**DOCKET NUMBER 50-483
CALLAWAY PLANT
UNION ELECTRIC COMPANY
RESPONSE TO REQUEST FOR ADDITIONAL INFORMATION
ON REVISION TO TECHNICAL SPECIFICATION 5.5.9
"STEAM GENERATOR (SG) TUBE SURVEILLANCE PROGRAM"**

**REQUEST FOR ADDITIONAL INFORMATION
REVIEW OF THE CALLAWAY PLANT APPLICATION
FOR REVISION TO TECHNICAL SPECIFICATION 3/4.4
TAC NUMBER: MB1214**

Figure R6-8. EDM Notch A10: Sleeved Region Outer Diameter, 0.003" depth

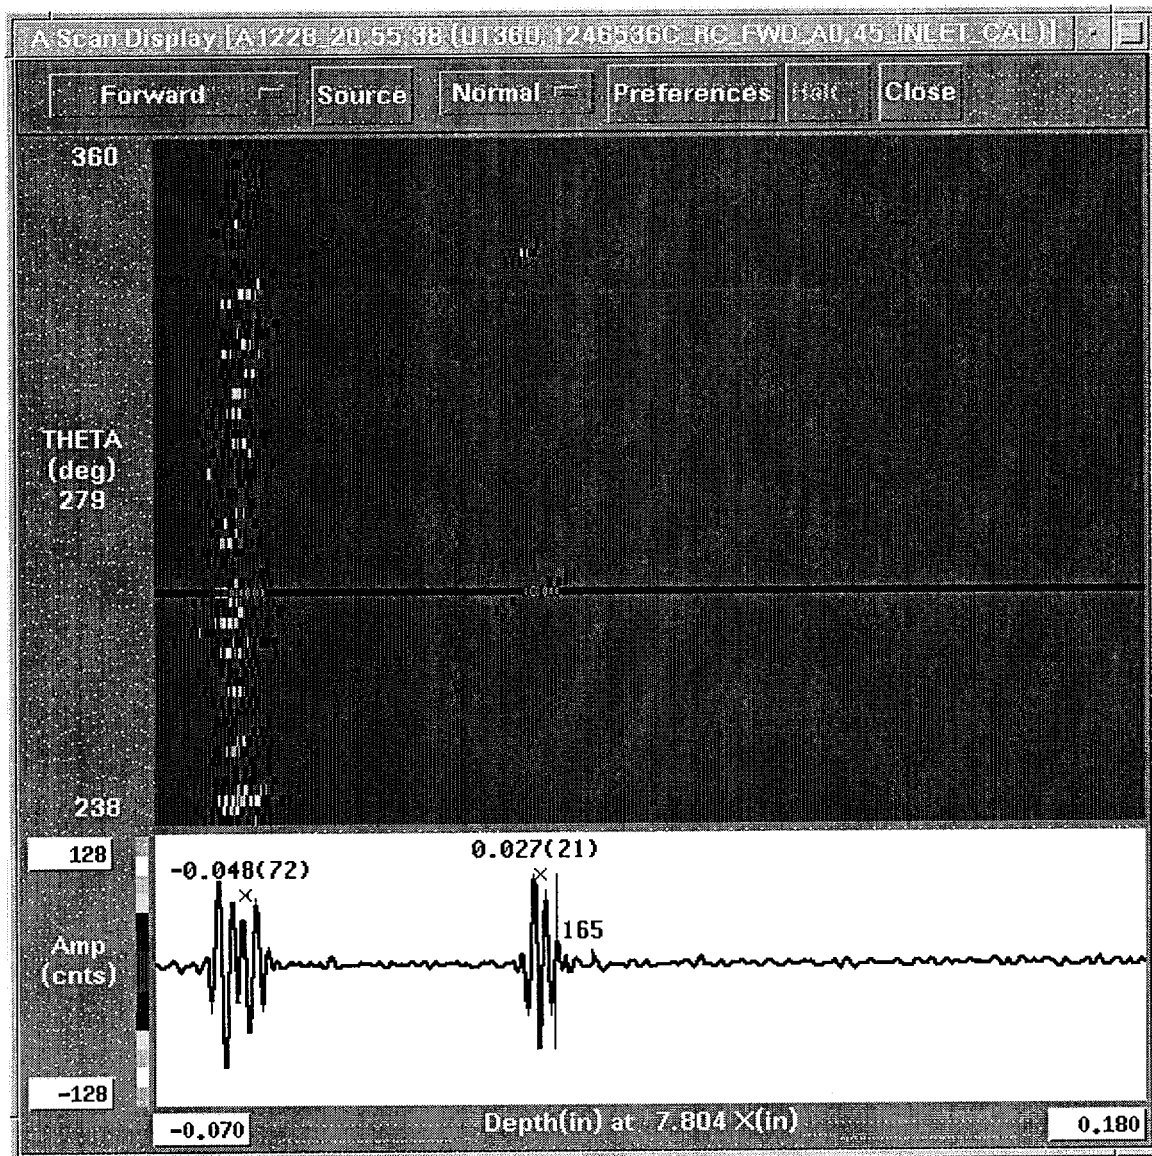
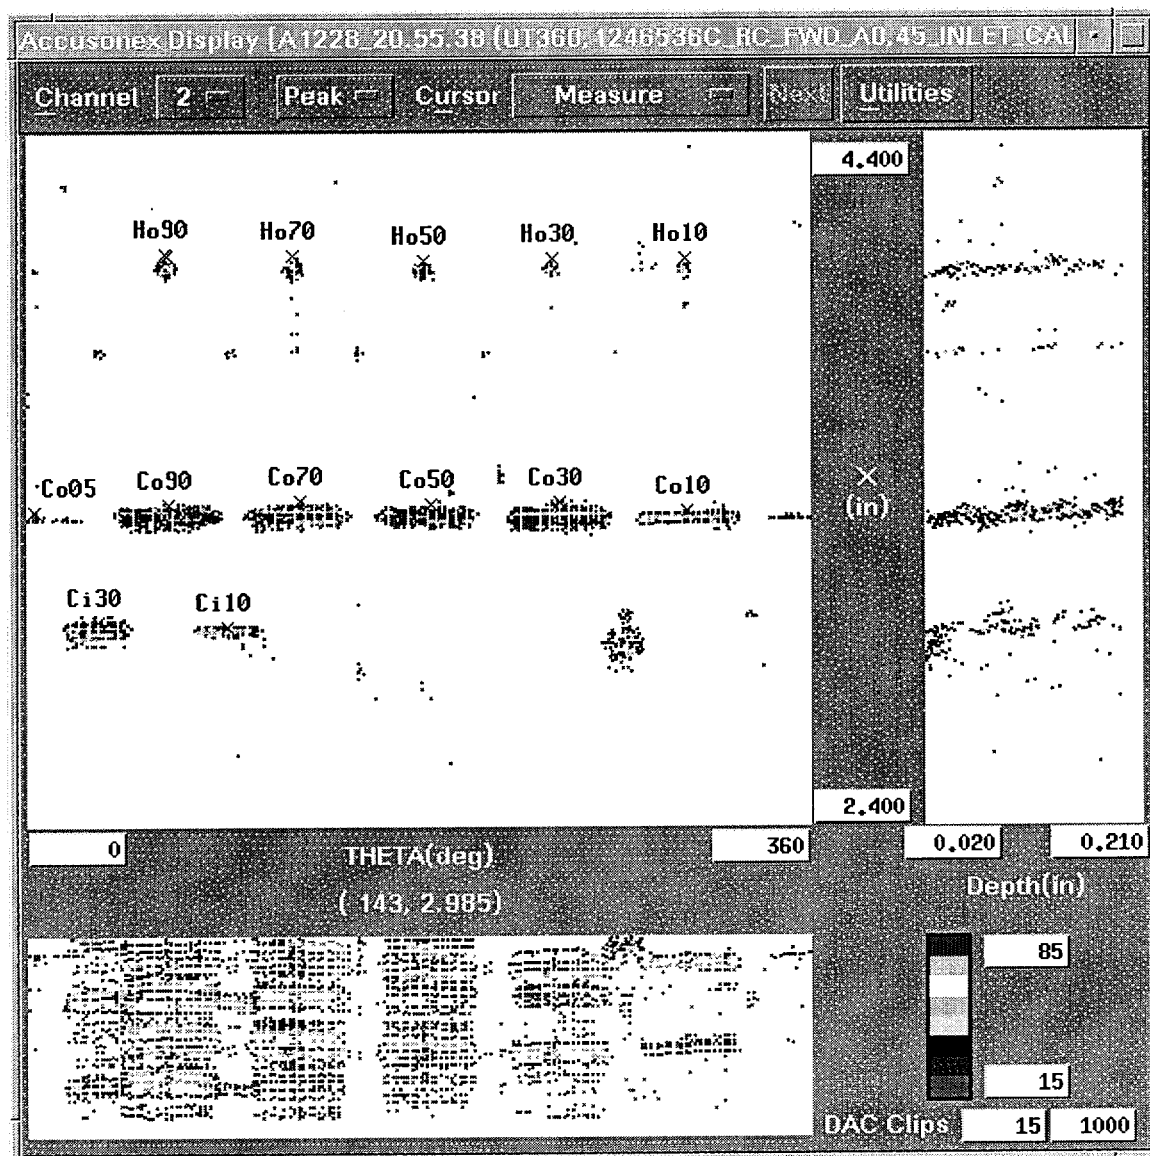
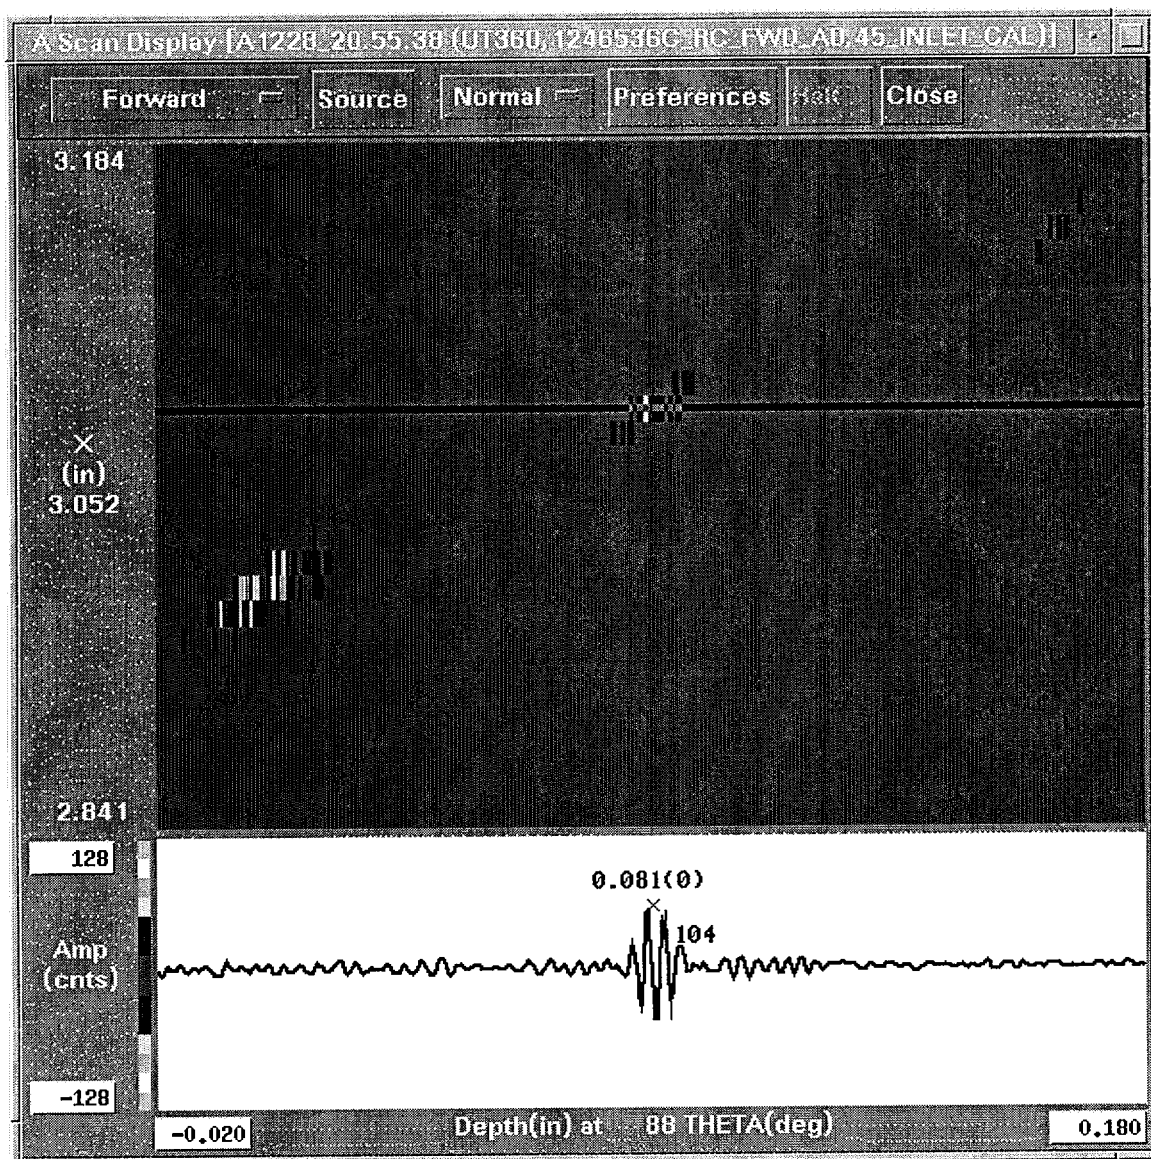
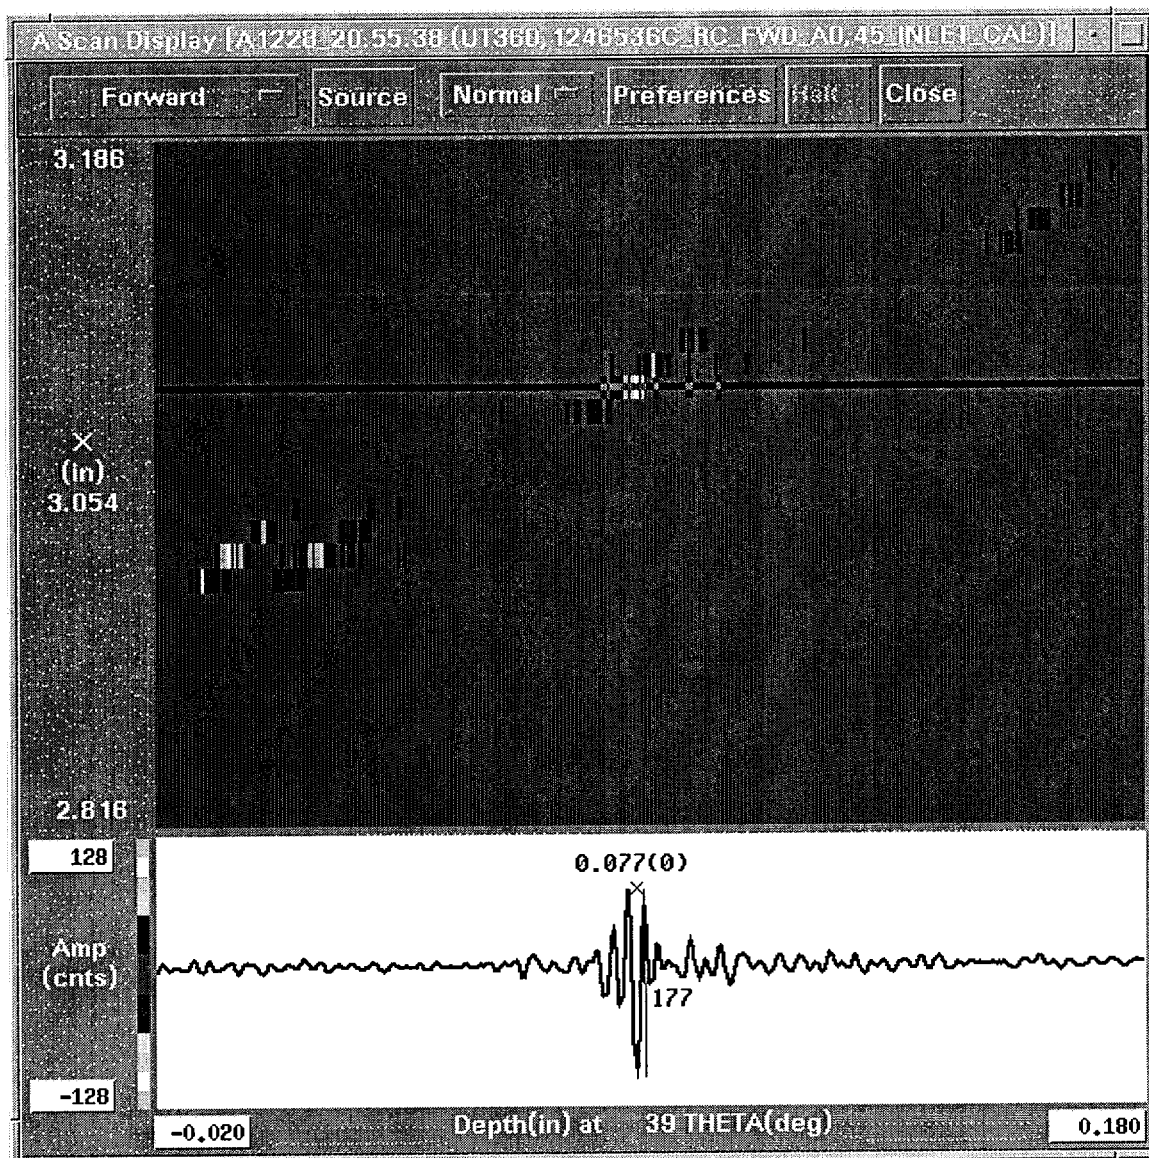
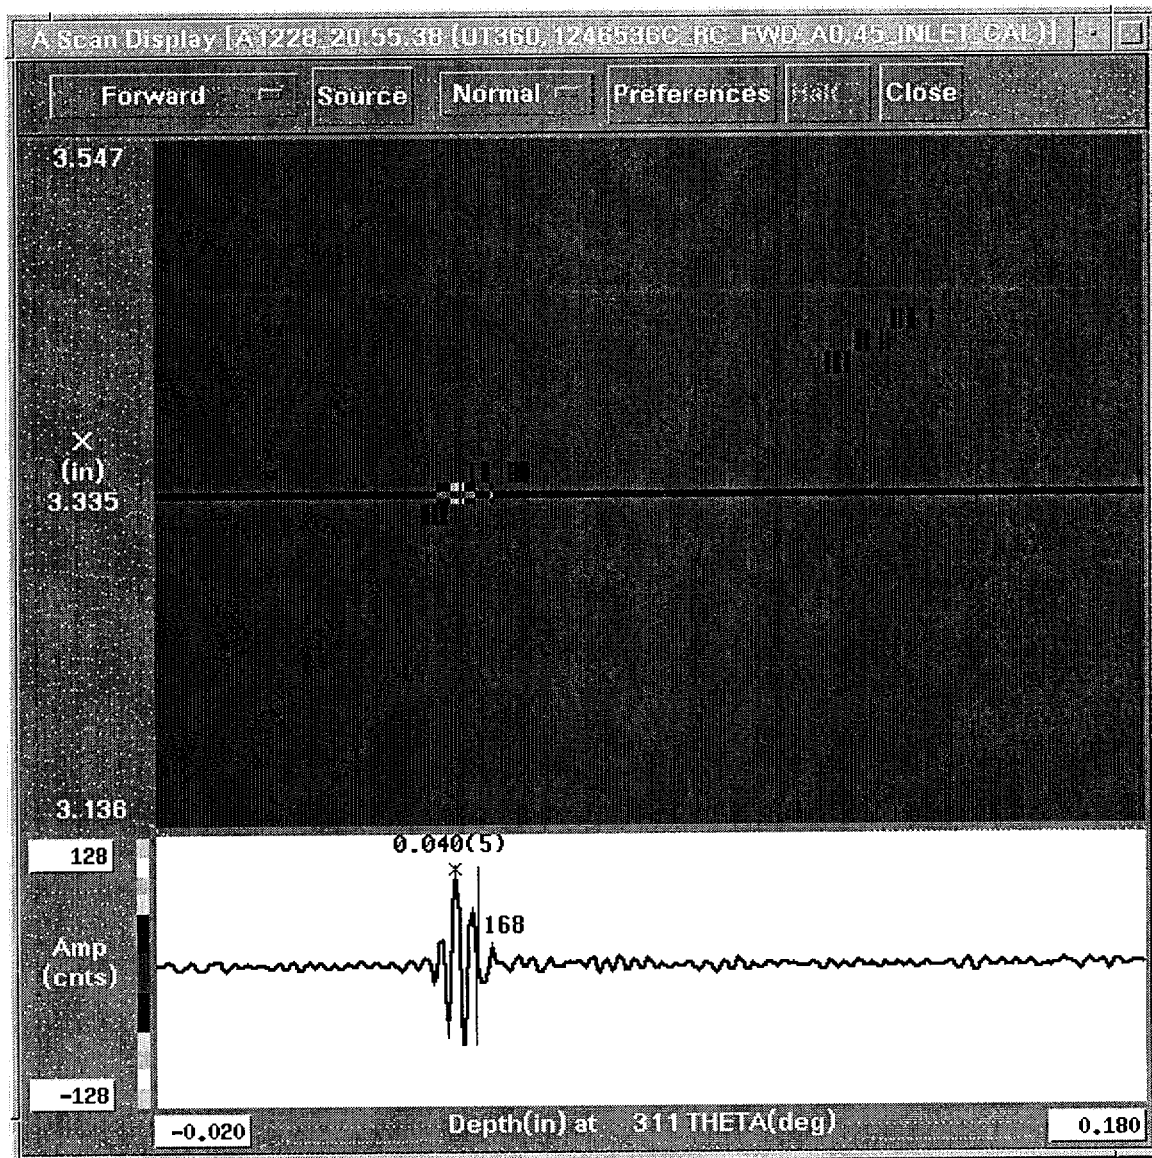
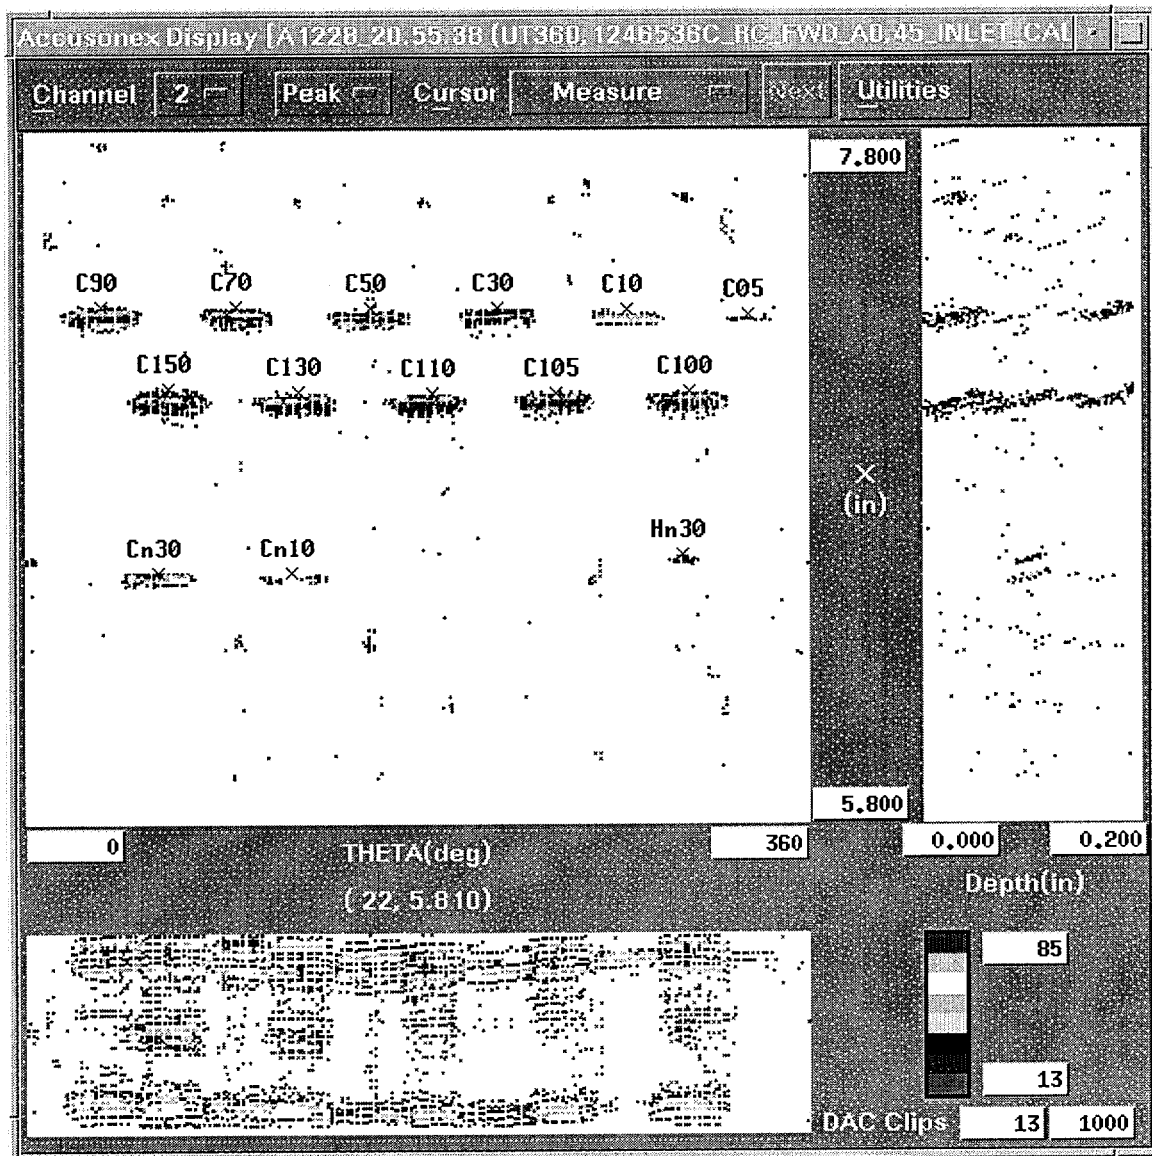
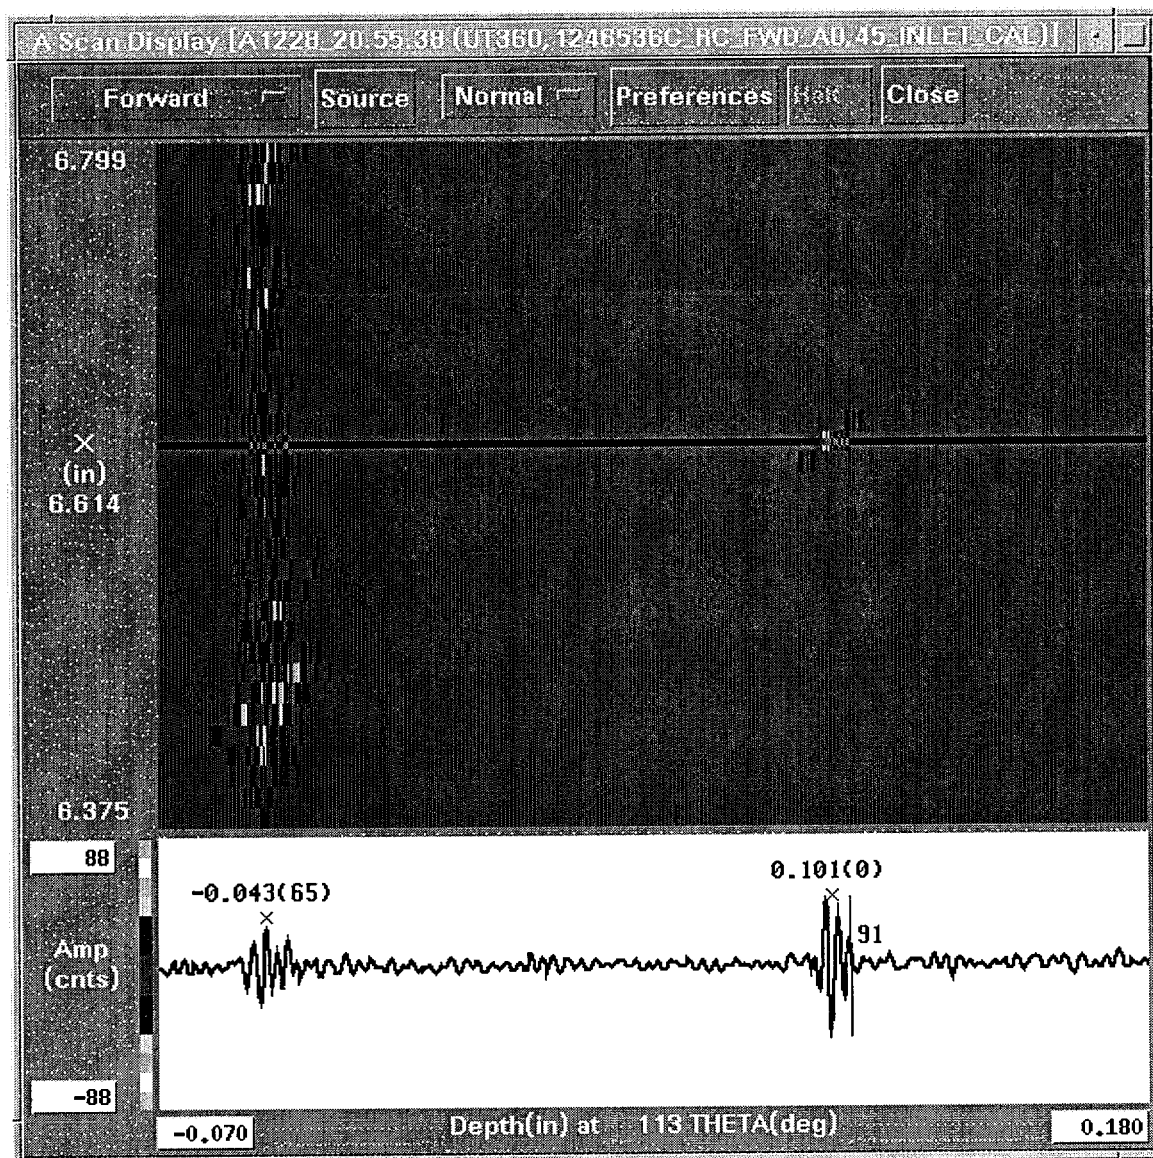
RAI # 6. During the meeting, FTI indicated that PWSCC detectability in the sleeve could be inferred from the ID notches in the UT calibration standards and the data sets containing pits. It is not clear to the staff how detecting EDM notches in the calibration standards or another degradation morphology such as pits would infer an ability to detect tight flaws such as PWSCC. Explain the basis for the statement that sleeve PWSCC ID defects will be detected, and the resulting sensitivity and POD, since the peer review (ETSS # 98404) only covers volumetric defects. Please provide additional discussion or, preferably, additional data to support the claims of the capability of the technique to detect PWSCC in the sleeve. (Question from the 6/7/01 meeting held with UE, FTI, and the NRC staff)

The assertion about the calibration standard and the inner diameter sleeve pit was to demonstrate sensitivity of the ultrasonic technique to inner diameter initiated flaws. The inner diameter pit provides a difficult cross-sectional target due to its cylindrical shape. This was felt to be a more challenging test of the detection capability of the shear wave transducers than the broad side of an EDM notch. The staff is correct in their opinion that neither of these flaws fully represent PWSCC, but these are the only morphologies available for evaluation since sleeve SCC cannot be fabricated.

To support the assertion that the system, (probe and technique) are sensitive to inner diameter flaws, three separate presentations will be offered. The first will show the sensitivity of the system to the inner diameter EDM notches in a calibration standard. The data was acquired in accordance with the

The flaws labeled "Ai" are parent tube inner diameter axial EDM notches. The flaws labeled "Ao" are parent tube outer diameter axial EDM notches. The flaws labeled with the first character "H" are EDM contoured bottom holes. Of interest is the detection of "Ai10", the 0.004 inch deep inner diameter notch.

This is the A-Scan plot showing the inner diameter corner reflection, (full skip) for the notch "Ai10". The notch is at the expected depth for the full skip, (two times the wall thickness) 0.086 inch. The peak to peak amplitude of this reflection is 65 counts out of a possible 256 counts or 25% full screen height.

This is the A-Scan plot showing the inner diameter corner reflection, (full skip) for the notch "Ai30". The peak to peak amplitude of this reflection is 108 counts or 42% full screen height.

This is the axial EDM notch that is used to establish the sensitivity and time-of-flight to depth calibration. The sensitivity must be set between 50% and 80% of the digitizer full scale. For an eight bit digitizer, the full scale is 256 counts (cnts). The amplitude of this reflection is 178 counts or (178/256), 70%.
